FALCON RESERVE FILING NO. 1  
COUNTY OF EL PASO, STATE OF COLORADO  
FINAL GRADING AND EROSION  
CONTROL PLANS

EL PASO COUNTY FILE NO. SP252

| FALCON RESERVE FILING NO. 1                                                                                                                                                                                                |  | GRADING & EROSION CONTROL TITLE SHEET |  | DATE: 07/27/2026 |  | SHEET 1 OF 7 |  | CR01           |  |

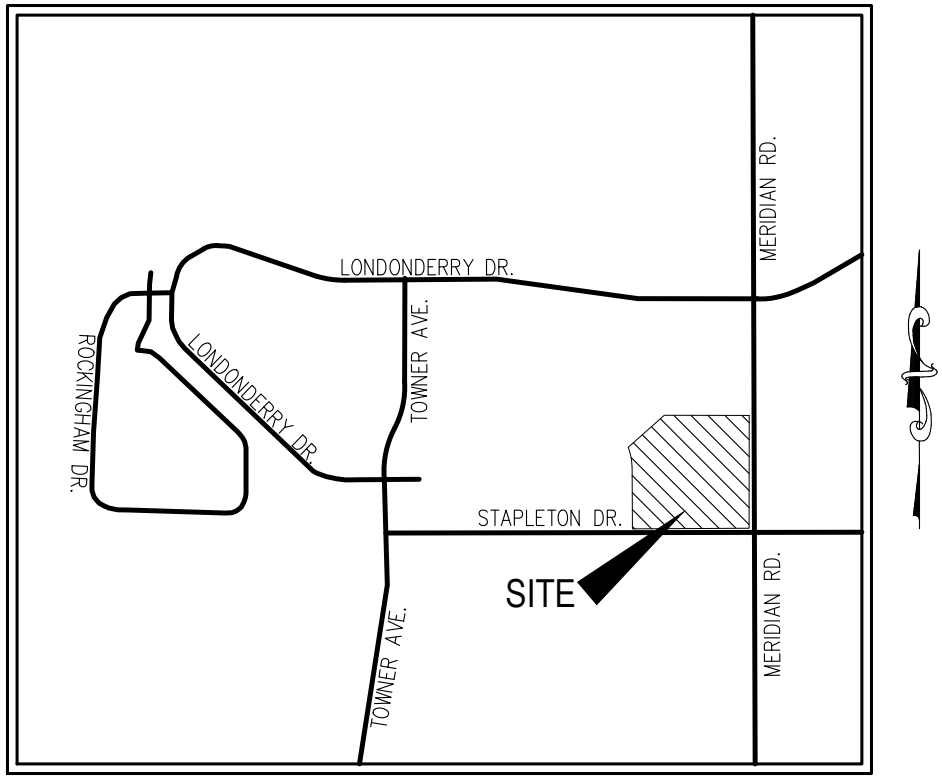
Use up to date standard GEC Notes as listed in Part II of the GEC Checklist. These notes are available on the County's Stormwater website in word format for ease of commenting.  
<https://publicworks.elpasoco.com/stormwater/>
